Subject: Response to the Staff's Questions Regarding the Root Cause Evaluation for  
Steam Generator Tube Rupture Event of February 15, 2000 (TAC No.  
MA8219)

**Response to Root Cause Evaluation Issues Nos. 2, 6, 14 and 16**

**Consolidated Edison Company of New York, Inc.  
Indian Point Unit No. 2  
Docket No. 50-247  
June 2000**

**Figure 1**  
**Indian Point-2**  
**R2C5 Noise Level of About 0.9 Volts Away from Flow**

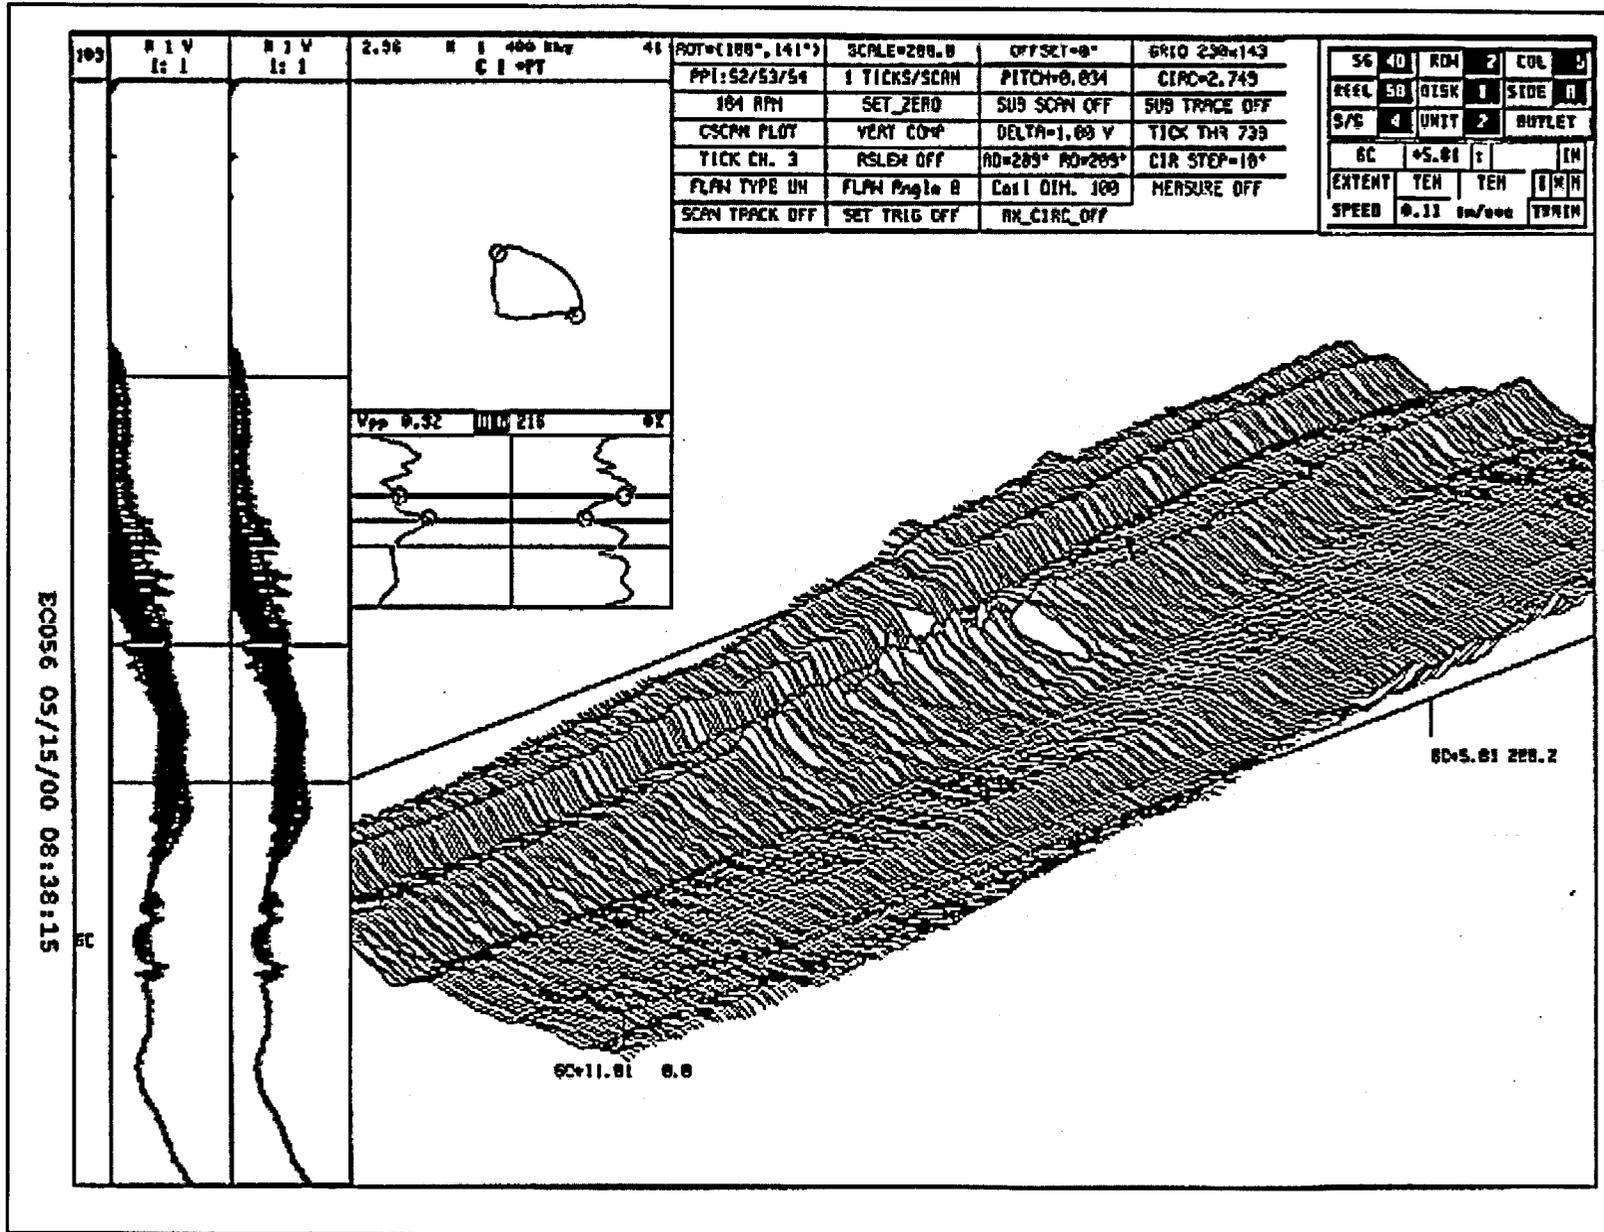
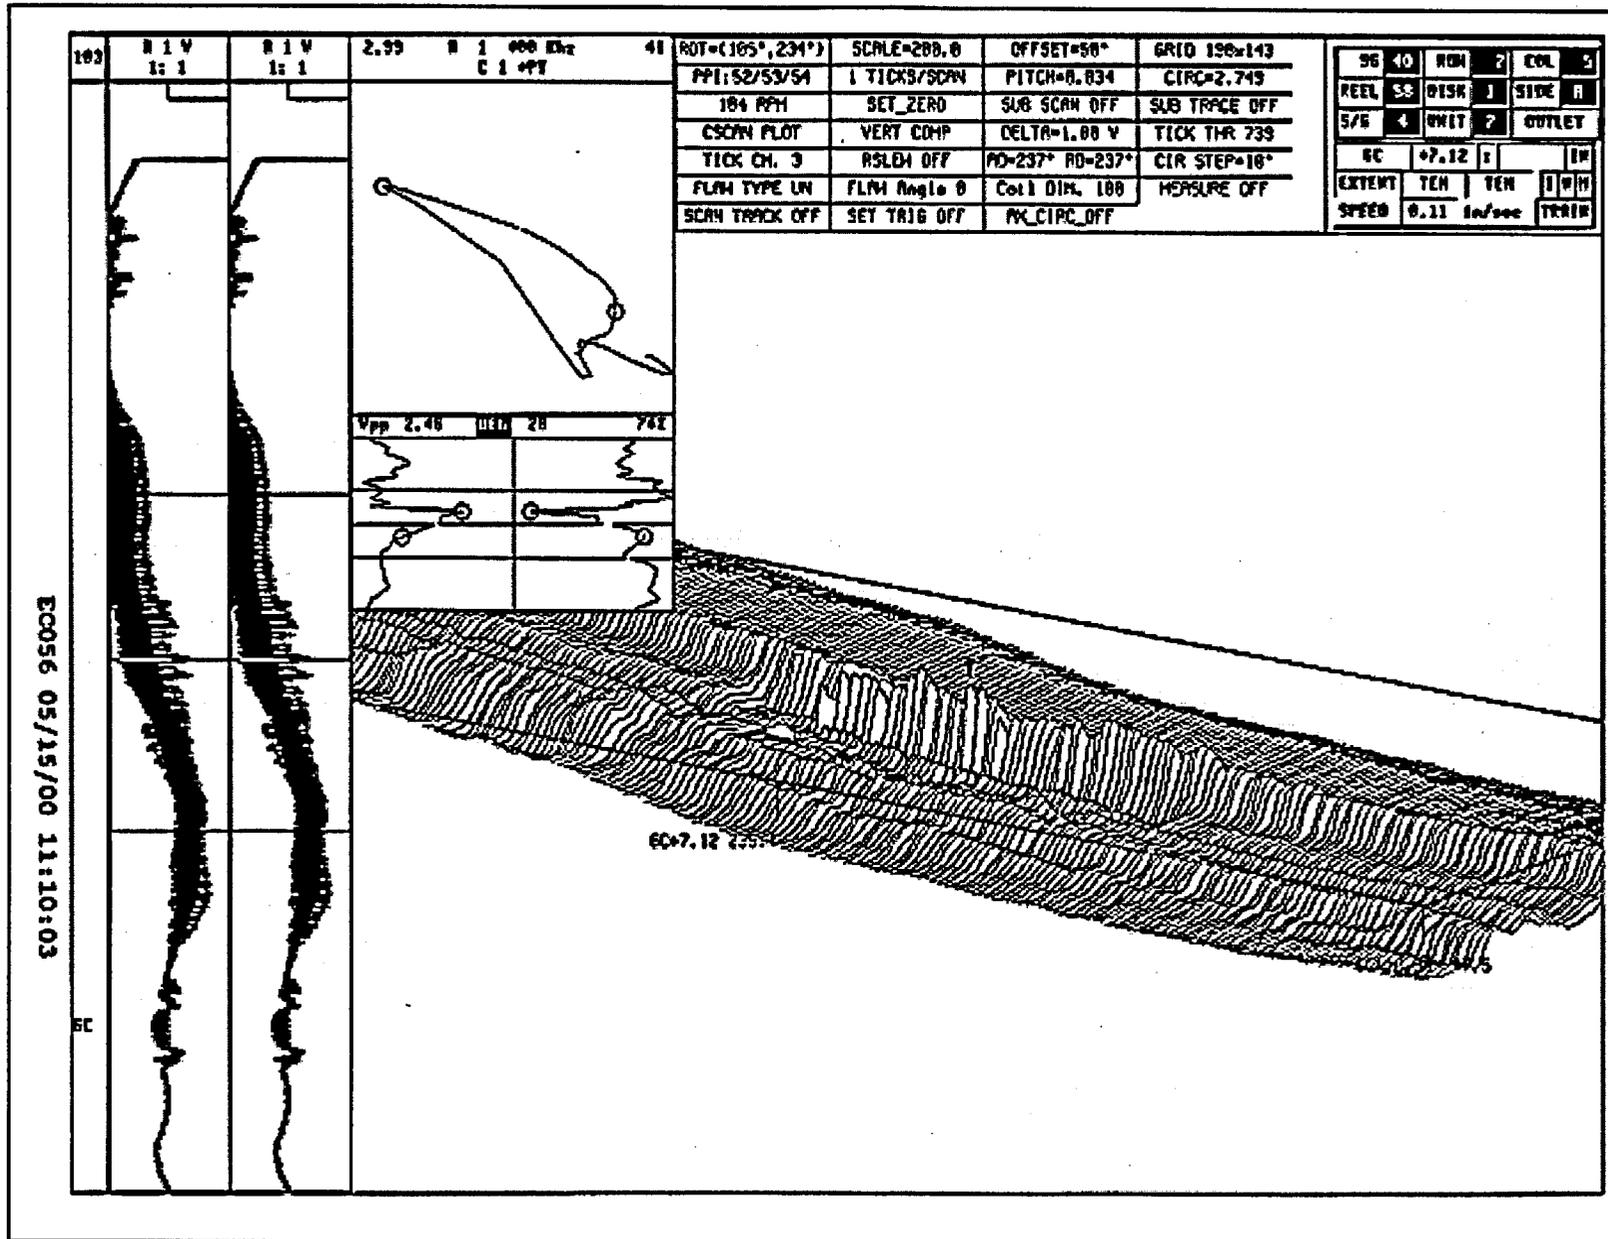
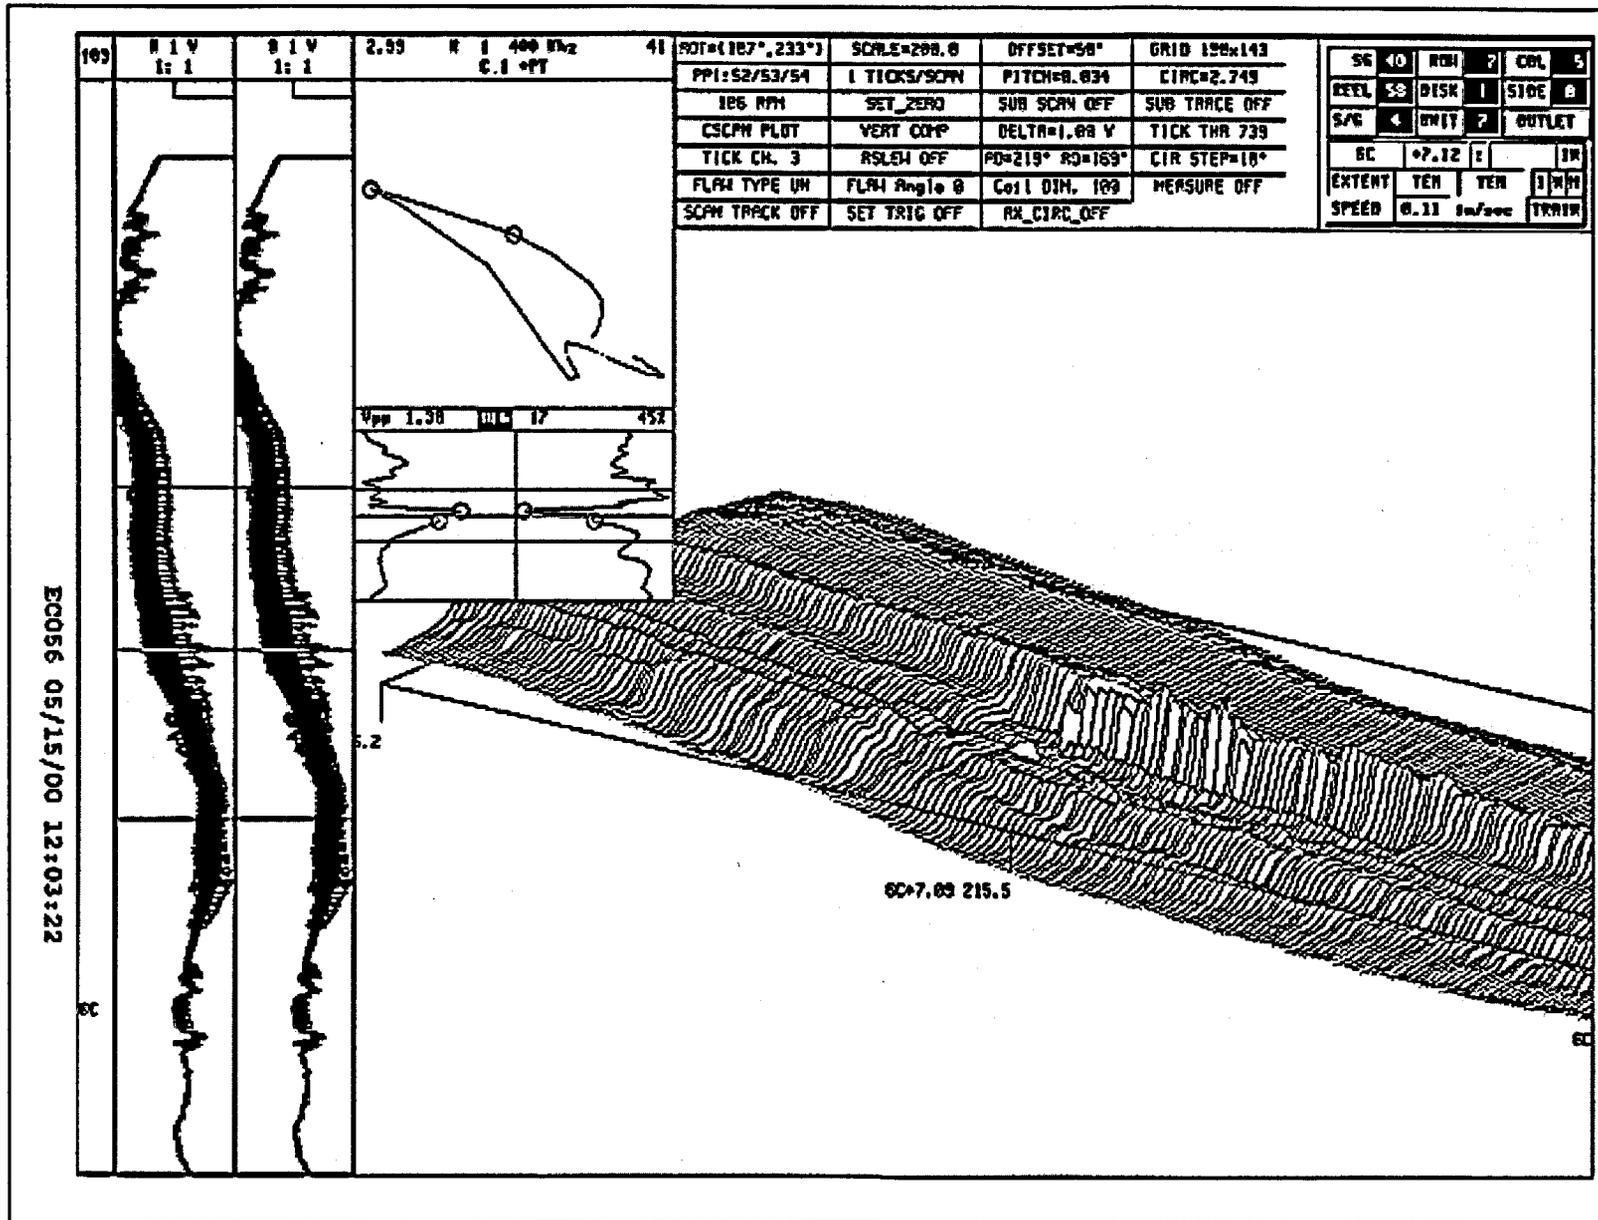
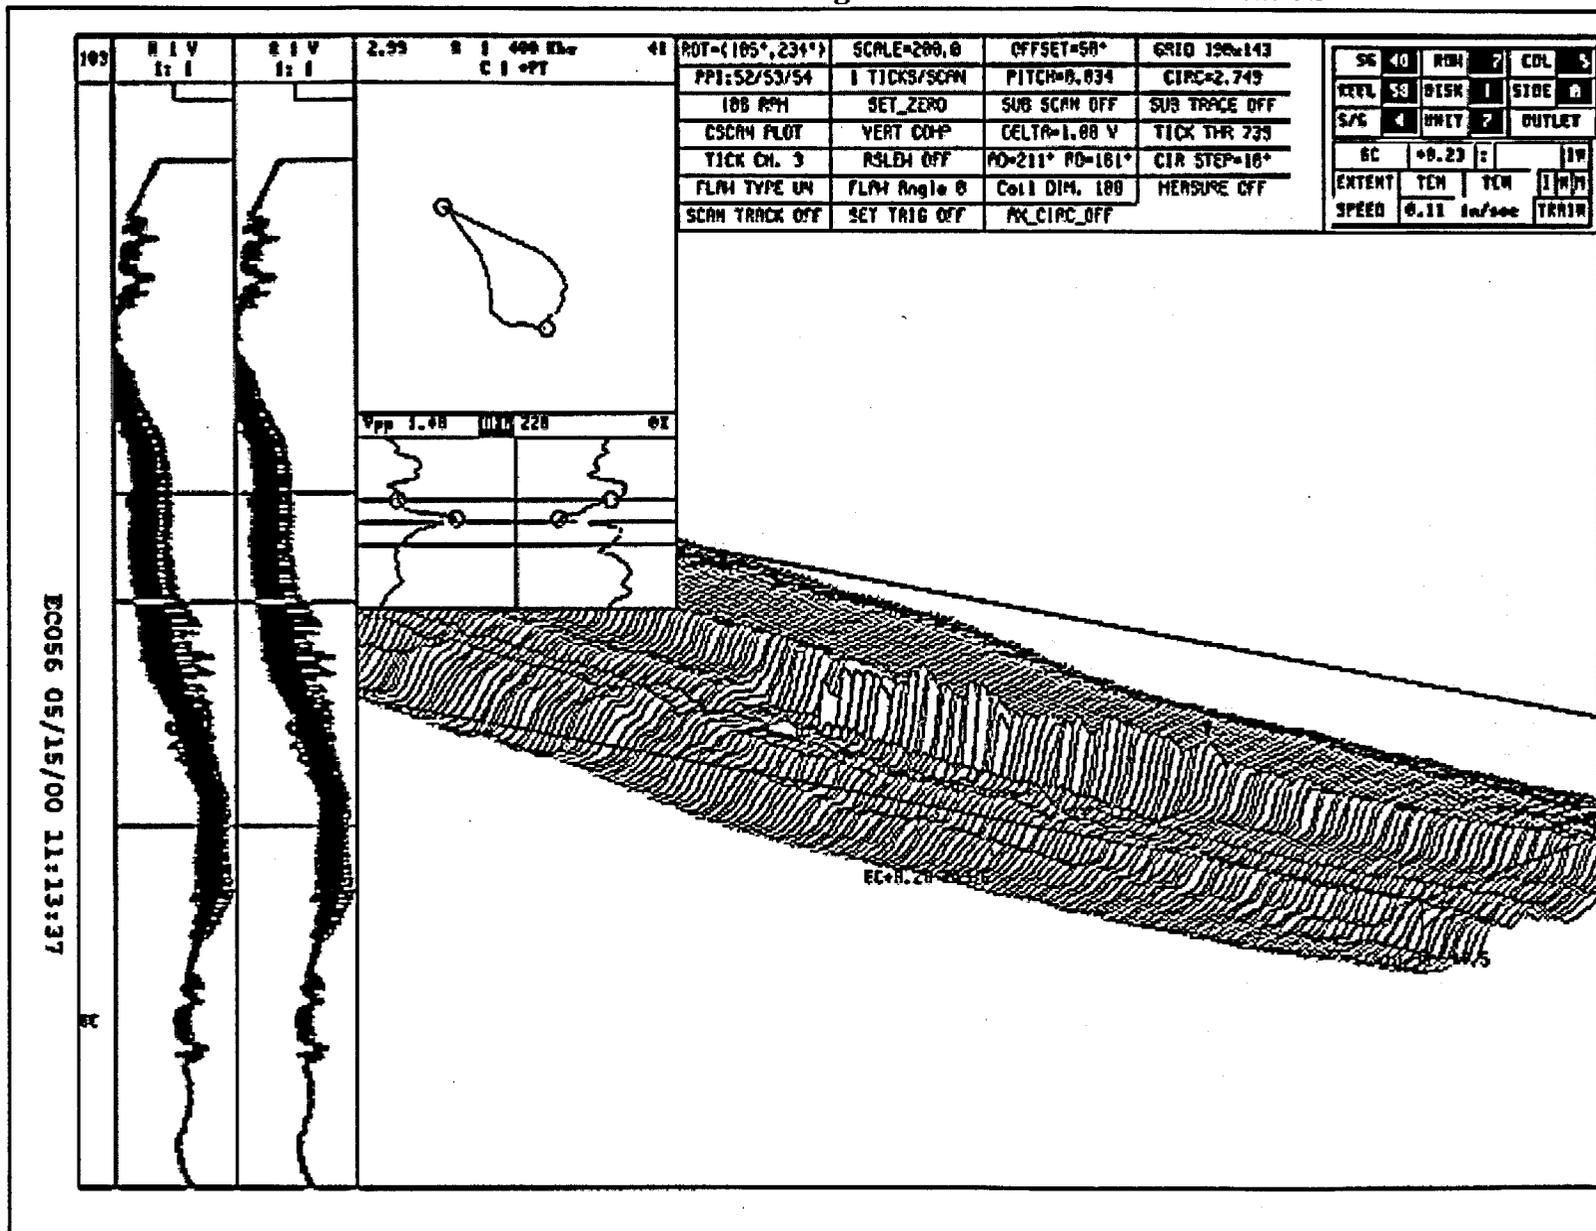
*Section 2 states that inability to detect the precursor indication in R2C5 due to noise was the principle cause of the leakage event and that the growth rate of the indication between 1997 and 2000 was moderate and not a principle cause. Given the low voltage response of the 1997 signal and the high signal to noise, what level of accuracy can be assumed for the depth of the 1997 indication? On what basis?*

The signal to noise (S/N) ratio varies along the length of the observed indication since both the crack and noise signals vary in amplitude and phase along the crack. For example, the amplitude of the crack signal drops off near the end of the crack leading to a low S/N ratio for any noise level at that point. The estimate for S/N therefore implies the maximum value of S/N for the crack indication. To support sizing of the indications, it is necessary to identify and separate the flaw part of the phase response from the noise response. Figure 1 shows the R2C5 noise signal of about 1 volt at a distance away from the observed crack. Figure 2 shows the maximum flaw plus noise signal to be about 2.5 volt which gives a signal to noise ratio of about 1.5. The portion of the total signal undistorted by the noise, representing the crack signal, is about 1.4 volt as shown in Figure 3 giving an alternate S/N about 1.4 at this location. The phase response of this crack signal must be used to size the indication and not the total peak to peak phase response. Figure 4 shows the overall crack plus noise signal at another location to be about 1.5 volt, where the estimate for the undistorted portion of the total signal is about 1 volt. At this location the noise level is about 0.5 volt and leads to a S/N of about 2.
